REGULAR PLANNING COMMISSION MINUTES

QUEENS CROWN ANNEXATION, ZONING AND SKETCH PLAN (ANNEX 2007-6 / ZON 2007-3 / SKETCH 2007-1)

Queen's Crown Annexation/Sketch Plan
January 22, 2009

Exhibit A
Queen's Crown
Annex 2007-6
ZON 2007-3
Sketch 2007-1

SKETCH PLAN

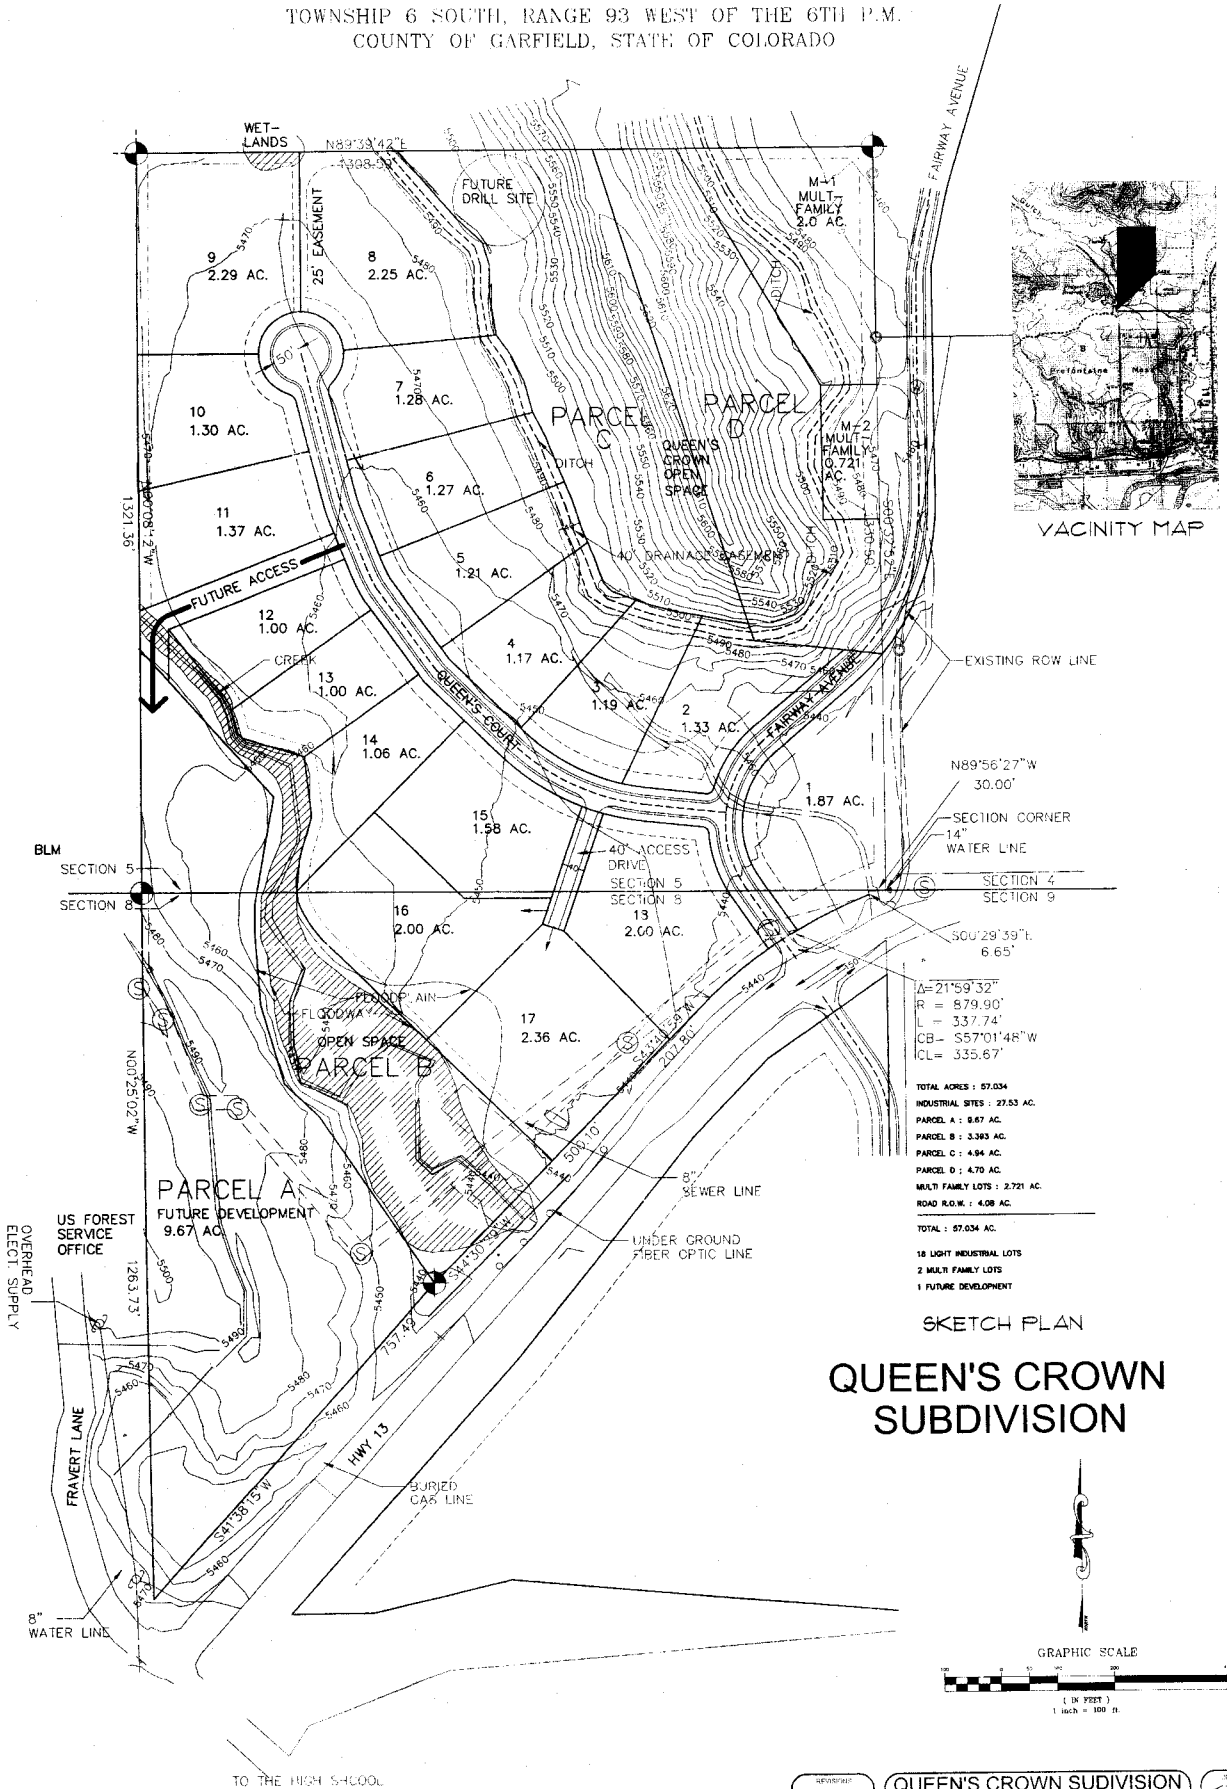
- The radius of the cul-de-sac
- Well pad site, how long is the permit for?
- Is residential development going to be in the Flood Plain area?

- 1.1.1. The revised map has a clear definition between the Light Industrial and the Medium Density Residential zoning. The parcel has been marked clearly on the zoning map as Light Industrial for 49.61 acres and Medium Density Residential for 7.42 acres. The Light Industrial does include Parcel A for future development.
- 1.1.2. With the change in use from Residential to Light Industrial, the mitigation and noise abatement for the firing range to the north will be reduced to berming along the northern edge of the property and landscaping along that berm.
- 1.1.3. A formal wetland delineation will be completed by the Wetland Consultants at Preliminary Plan stage.

- 1.1.4. The applicant has been investigating the lining or piping of the irrigation ditch that passes through the property to avoid irrigation leakage. There will also be a catchment ditch located below the existing wetlands to catch any leakage from the pond to the north and divert it into the drainage system for the project. The detailed drainage report will be prepared at Preliminary Plan.

- 1.1.6. The Medium Density Residential lots are shown with open space. The actual area for development will be on slopes of less than 30% and will be further detailed at Preliminary Plan once the road alignment has been determined and final elevations for the road shown on cross sections.

- 1.1.7. The Preliminary Plan will have a more detailed geotechnical analysis of the site and the Grand Tunnel Ditch.
- 1.1.8. The site for the Future Drill Site at the northern center of the property as shown on the site plan will be retained for that use only. All lot lines have been taken away from the site. The applicant is seeking a letter from Antero Resources II Corporation that they are not interested in drilling this site. Their lease expires in 2009.

- 1.4.1. The waterline on Fairway Avenue has been changed to a 14" PVC C900 waterline.
- 1.4.2. The applicant will work with the City to either develop a booster pump station to develop adequate pressure in the subdivision or an additional pump to fill the water tank. The developer is also interested in working with any other subdivisions to arrive at a satisfactory water system for the project and the area.
- 1.4.3. An alternate to specific solutions for the water system would be to join a Special Improvement District for future development of a water system in the area.

- 1.5.1 The Site Plan shows a 75 foot radius for the cul de sac.
- 1.5.2. Kevin Wayland, of the Rifle Fire Department, has been contacted about the length of the cul de sacs. He will request that the buildings be fire sprinkled with the longer roads proposed.

Most of the items listed in Dick Duessen's letter of August 5, 2008, will be addressed at Preliminary Plan as Preliminary Plan requirements. It was agreed at the meeting that the existing sewer easement will show on the Final Plat and not on the Annexation Map. The limits of the wetland area have been shown on the site plan.

Mr. Isom explained that they are working with the Fire Department on the radius of the cul-de-sac, and working with the engineers on the comments from City's Consulting Engineers. The flood plain is located above the irrigation ditch. For the well site, their right to drill expired.

A revised Annexation Map is being prepared by Bookcliff Survey Services, Inc. per the changes by SGM and will be forwarded on when finished.
